## National Service Technical Bulletin

### 2018-01-047 - Service Campaign 6MS - Retractable door mirror switch contact point wear

Honda Australia wishes to advise that a Service Campaign has been initiated for the **Accord 13-17YM, Jazz 15-16YM, HRV 15-16YM, Odyssey 13-18YM.**

#### SYMPTOM AND CAUSE

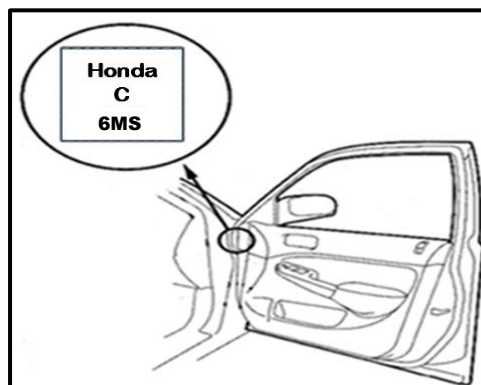
Due to an inappropriate surface treatment, frequent use of the door mirror retraction switch could wear the contact points.

Over time, this wear can oxidize increasing the resistance in the switch resulting in the mirror retracting whilst driving/parking or may not operate at all.

When the vehicle presents for service or general repair, replace the Mirror Switch in concern as per Maris Instructions.
